# Technical Service Bulletin

GROUP <b>CAMPAIGN</b>	NUMBER <b>18-01-010</b>
DATE <b>FEBRUARY 2018</b>	MODEL(S) <b>TUCSON (TL)</b>

**SUBJECT:** EVAPORATOR TEMPERATURE SENSOR REPLACEMENT AND ECU UPDATE (SERVICE CAMPAIGN T2U)

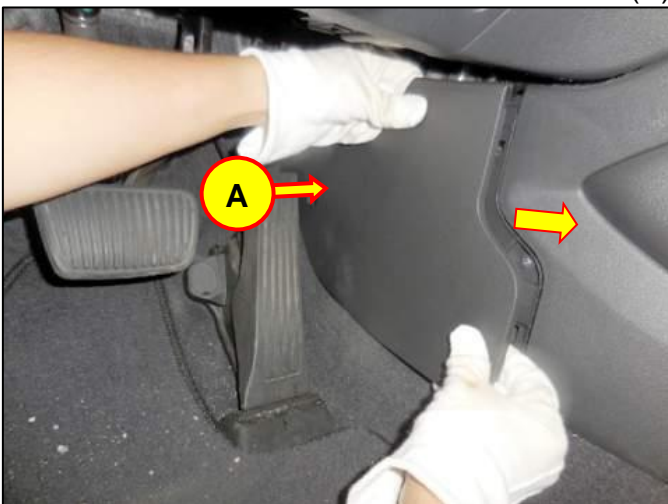
1. Access the Evaporator Temperature Sensor by removing the LH console side cover (A).
  - Pull the ends of the cover towards the left side of the vehicle to release the mounting clips (B).

- Then slide the LH console side cover (A) towards the rear of the vehicle to remove the cover.

2. Remove and replace the Evaporator Temperature Sensor with a new campaign part.
  - Release the connector lock (C) to disconnect the temperature sensor harness.
  - Rotate the temperature sensor (D) counter-clockwise 90 degrees to remove the sensor.

- Install the new Evaporator Temperature Sensor.
- Then reinstall all removed parts in reverse order of removal. **Be sure to reconnect the sensor connector.**
